SMYRNA MUNICIPAL PLANNING COMMISSION

MEETING MINUTES DECEMBER 7, 2023

1. Addition to Villages of Valley Green, Section IV - **Request to be deferred**
 Enon Springs Road W & Wildwood Drive
 Owner / Developer: JSD Holdings

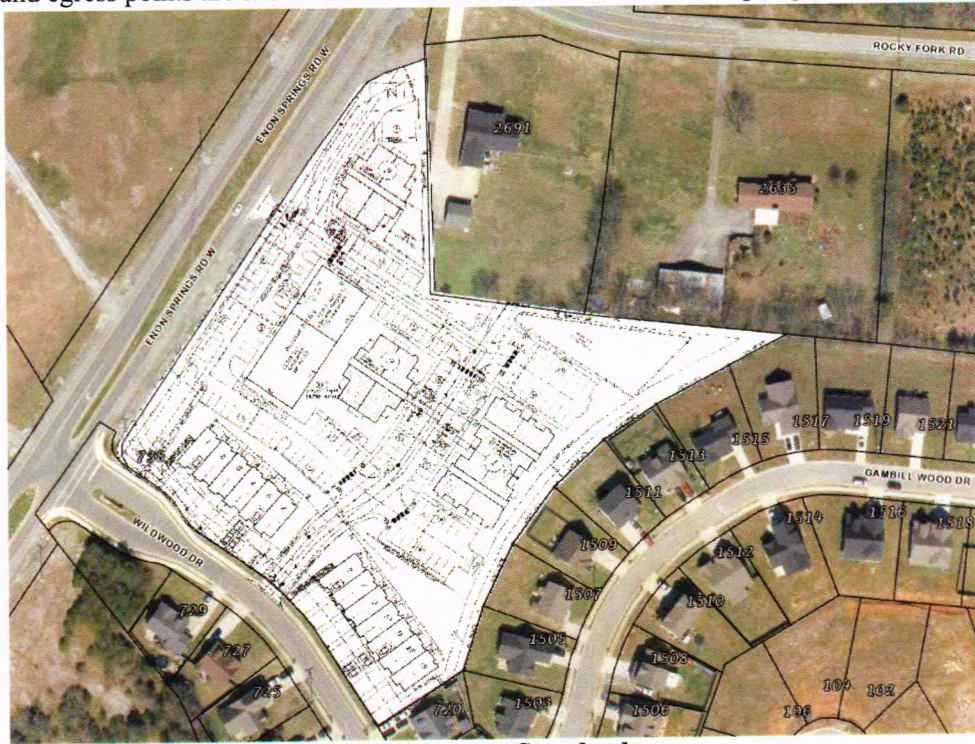
1. Provide architectural elevations for the commercial building showing all four sides, the height of the building, the material percentages per wall face, and the material percentages for the overall building.

2. Provide architectural elevations for the three proposed apartment buildings and the proposed townhomes showing the heights of the buildings and proposed materials. Depending on the height of the building, a wider drive aisle may be required.

3. Please show additional dumpsters for the development. Provide dedicated trash receptacles for the commercial building.
4. Please show on the plans whether the townhomes will be a for sale product or rental. This affects how the units are provided sewer.

5. Extend sewer to the property to the north east (Gambill).
6. Provide an auto-turn using the Town of Smyrna ladder fire truck. Auto-turn cannot enter parking spaces when turning.

7. 5,250 SF of commercial is allowed by the approved PUD. The proposed building on the plans show 9,000 SF. Either reduce the size of the building or request a PUD amendment to allow a larger commercial building.

13. Please show a loading/unloading zone for the commercial building which does not interfere with the auto-turn.
14. Add curbing to the cross-section of the proposed paving.

15. Provide a Type C landscape buffer between the multifamily uses and all of the surrounding single family uses.
16. Show landscaping/streetscaping between Building 2 and the commercial building.

- 17. Utility plans are under review.
- 18. Please show handicapped parking spaces spread throughout the development to serve all the apartment buildings as well as the commercial building. Handicapped people should not be crossing drive aisles to reach their destination building.

- 2. Davis Park Commercial, Lot 4
Corner of Old Nashville Hwy. & Davis Park Dr.
Owner/Developer: Richland South LLC/Beltway LLC

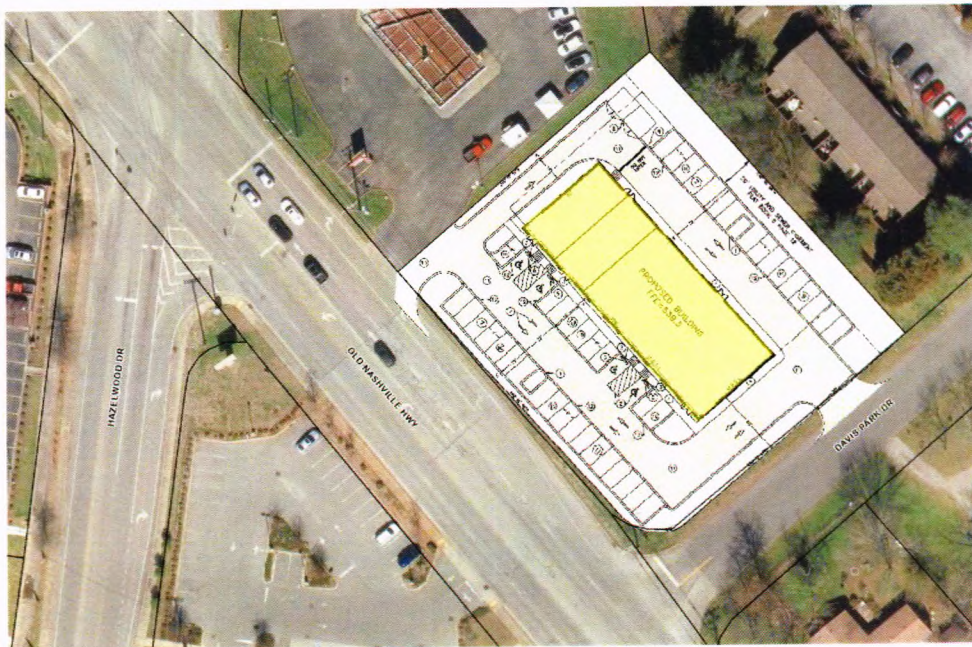
1. A shared access easement will be required for the adjacent tract to the northwest. If one already exists, please provide documentation.
2. Based on the construction type, the building will be required to be sprinkled.
3. Adequate parking is shown to meet the Zoning Ordinance. However, the third space within this building cannot be used as a restaurant in order to maintain adequate parking for the site.
4. It appears that the dumpster enclosure is set up for two dumpsters for three businesses. If this proves to be inadequate and a third dumpster is needed in the future, the enclosure will have to be rebuilt to enclose all needed dumpsters.
5. Submit utility construction plans.

3. Redstone Federal Credit Union
 Corner of Sam Ridley Pkwy. W. & Huginn Ln.
 Owner/Developer: Redstone Federal Credit Union

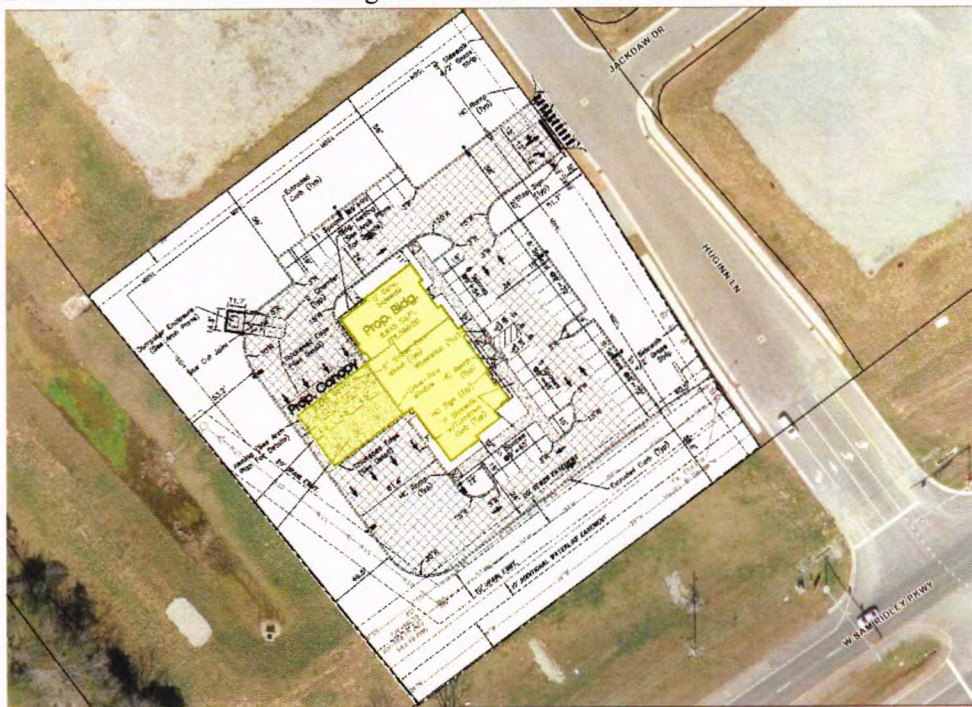
1. Please show adequate streetscaping along Huginn Lane meeting MTEMC requirements for landscaping in an easement as well as streetscaping requirements.
2. Due to the number of parking spaces provided, the second tenant cannot be used as a restaurant.

4. Stewart Creek Station
NE Corner of Poplarwood Drive & Almaville Road
Owner/Developer: Mayan 2022 Inc/Hardik Patel

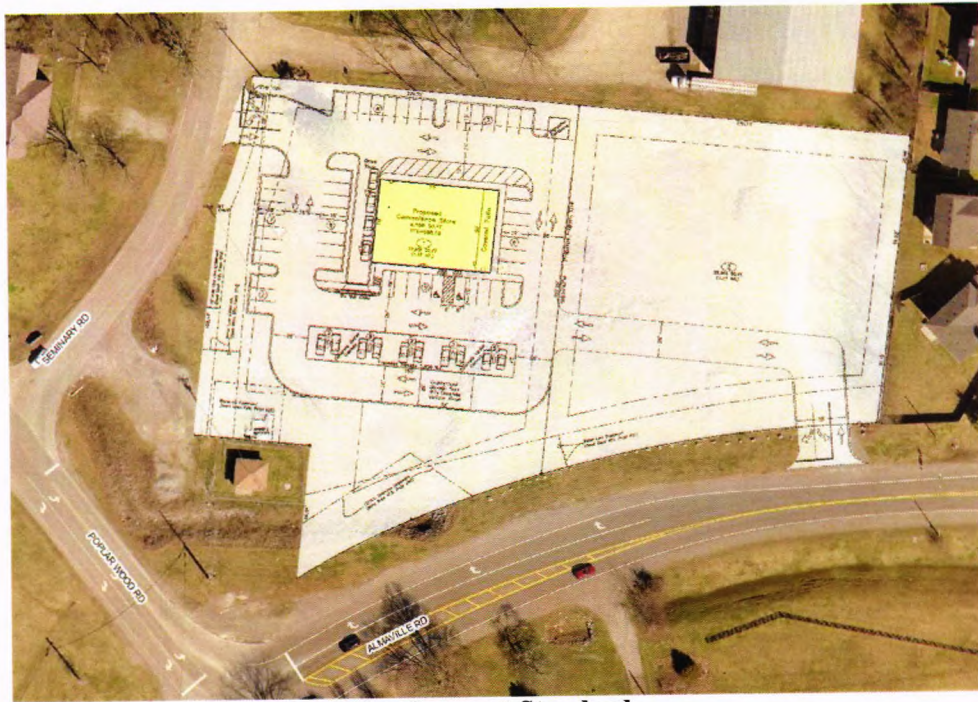
1. The subdivision plat creating the two lots is required to be recorded prior to issuance of a building permit. This would need to include the ingress/egress easement across Lot 2 benefiting Lot 1.
2. An entrance is shown on Almadale Road (SR-102). The current gravel drive at this location has not been permitted by TDOT. TDOT approval will be required for the entrance and it must meet all TDOT design standards.
3. Any improvements recommended by the traffic study must be completed by the developer.

1. A left turn lane is shown on Almadale Road into the Project Site.
 2. Begin the RIGHT TURN LANE from Almadale Road onto Poplar Wood Road after the Project Site entrance in order not to confuse drivers with the Project Site entrance.

3. The site distance has been checked for the Project Site exit onto Almadale Road.
 4. Bring signal equipment up to current Town of Smyrna standards.
 5. Install connection to Smyrna Traffic Operations Center for remote phasing.

6. Replace signal heads as needed for new turning movements.
 7. Conduct Timing Study to input different timing plans for peak hour traffic. This signal will be a part of the overall ITS project Phases 3, 4, and 5.

8. Make the Poplar Wood Road at Foxland Drive intersection an all way stop.
4. What is the fireflow? This site needs a minimum of 1500 GPM at 20 PSI
 5. Provide the construction type as this may affect the required minimum fire flow.

5. Zomi Christian Church, Inc.
 815 Rock Springs Road
 Owner/Developer: Marjulus Holdings, LLC

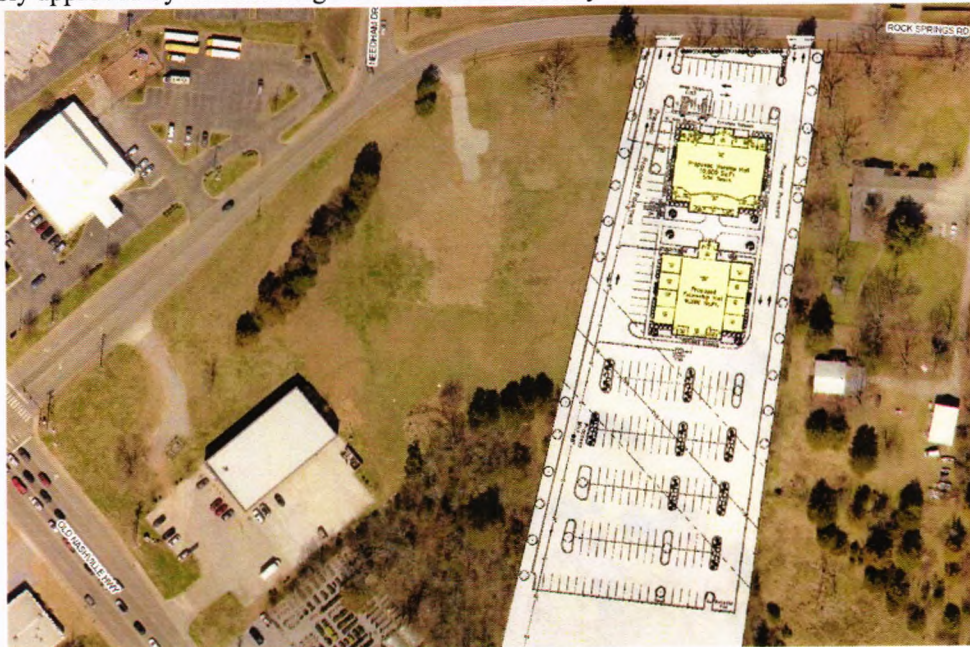
1. Submit construction plans for the public water and sewer mains.
2. The sanitary sewer easement across the adjoining property to Old Nashville Highway has not been dedicated to the Town as a public easement. A public sewer line is shown within this easement. For this to occur, the easement will have to be dedicated to the Town by the adjoining property owner.
